KAS Group Knitwear Ltd.

Bypass Road, Peyarabagan, Joydevpur, Gazipur
(23.977060 N, 90.376332 E)

1st November 2015

Observations

As-built floor plan

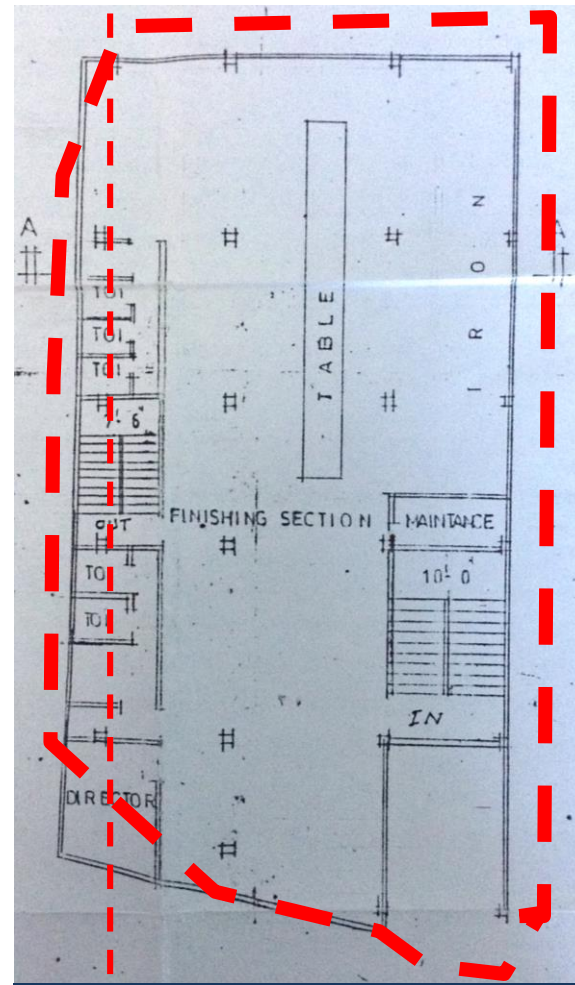
Differences at:-
Column locations
Floor extents and cantilevers

Structural drawings were not
presented

Item No.	Observation	Recommended Action Plan	Recommended Timeline
1	Discrepancies between Permit drawing and As-built condition	Building engineer to be appointed to produce accurate and complete as-built documentation.	6-weeks
2	Discrepancies between Permit drawing and As-built condition	Building engineer to produce accurate and complete as-built documentation. A note should be put on the drawings warning that no extension of the building should be permitted without structural checks being carried out.	6-months
3	Cardboard and packed boxes stacked in dense piles	Building Engineer to create controlled loading plans for all floors designating location and intensity of storage.	6-weeks
4	Cardboard and packed boxes stacked in dense piles	Continue to implement load plan.	6-months

Uncontrolled high storage loads on floors

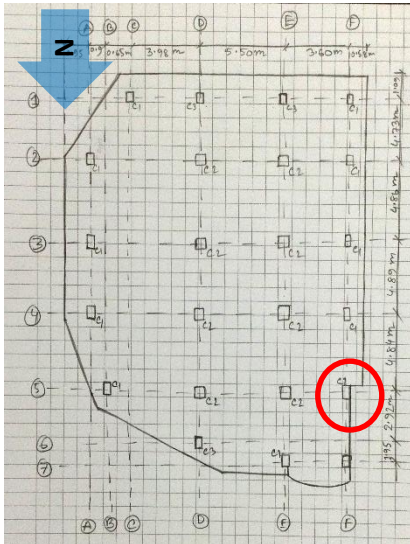
Stacked cardboard and packed finished goods stored at 1st and 3rd floors.

Vibration on 1st floor was noticeable when packing process is ongoing.

Note flat slab at 2nd Floor: punching shear failure is a concern. Excessive storage must be prevented.

Building Engineer to create controlled loading plans for all floors which will designate where storage can be placed.

Exposed rebars of slabs/beams at South elevation

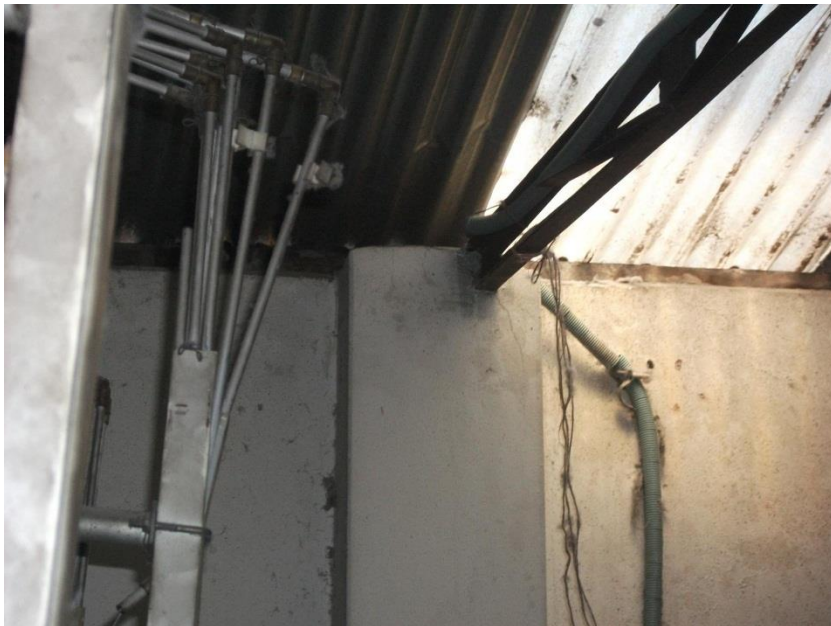
Exposed beam and slab rebars observed from cantilever portion at South elevation. Indication of possible further expansion contradicting the permit drawings. Factory Management should ensure that this should be avoided. Edge columns may become overstressed.
